Item 6.**Development Application: Sites 7 and 17, 960A Bourke Street, Zetland – D/2017/564****File No.:** D/2017/564**Summary**

Date of Submission:	The application was lodged on 5 May 2017. Several amendments including significant design changes have been submitted since lodgement. The most recent amendments were submitted on 24 April 2019.
Applicant:	Mirvac and Landcom
Architect/Designer:	Tzannes (original submission Silvester Fuller)
Developer:	Mirvac and Landcom
Owner:	Landcom
Cost of Works:	\$125,721,654 (original submission \$98,514,463)
Zoning:	B4 - Mixed Use zone - Permissible With Consent
Proposal Summary:	<p>Consent is sought for a new mixed-use development on Site 7 and Site 17 in the Green Square Town Centre (GSTC) comprising the following:</p> <ul style="list-style-type: none">• Site 7 includes a new 16 storey building plus roof plant with 123 residential apartments on Levels 6 - 18, retail uses on Level 1, commercial uses on Levels 4 and 5, and an entertainment facility (cinema) across Levels 1-5. A landscaped podium roof terrace is on Level 6.• Site 17 includes a new 13 storey building plus roof plant with 71 residential apartments on Levels 2-13, retail uses on Leve

Figure 41: Ground floor (left) and First Floor (right) plans of the subject corner

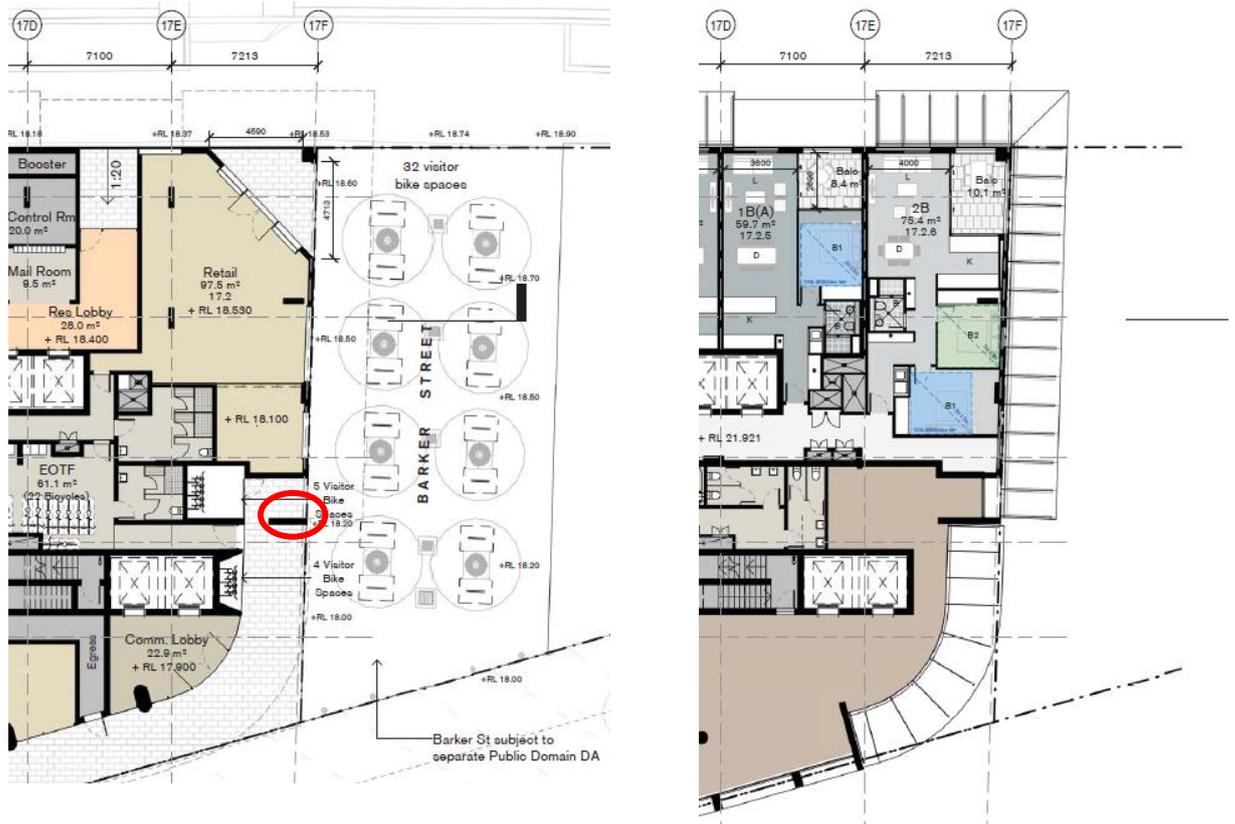
163. Design studies were undertaken by the applicant to reduce the perception of the double height blank facade that under the amended proposal is adjacent to the recessed visitor bike parking that faces the Plaza. The applicant maintains that visual amelioration of the blank walls occurs through the effects of light on built form, texture and material.

164. It is nevertheless considered that this building element requires further design refinement to ensure that an optimum design solution is achieved for this prominent corner. This should include investigating the suitability of the blade wall (circled in red in the Figure below) near the recessed visitor bicycle parking spaces. A condition to this effect is recommended.

Figure 43: Left - curved element of previously amended scheme, right - curved element of final amended scheme with fins to two upper level units in curved element of podium on Site 7.

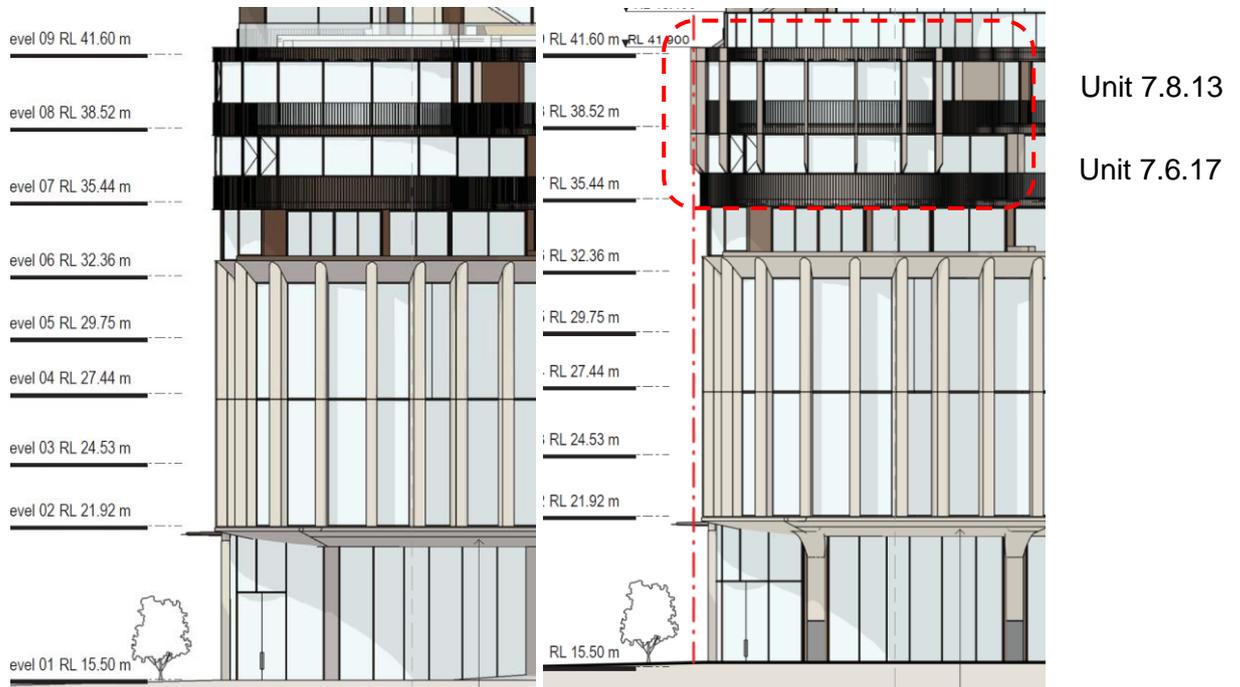
166. Vertical fins have been provided to apartments 7.6.17 and 7.8.13, which are located in the top two floors of the three storey curved element of the building in the south west corner of Site 7.
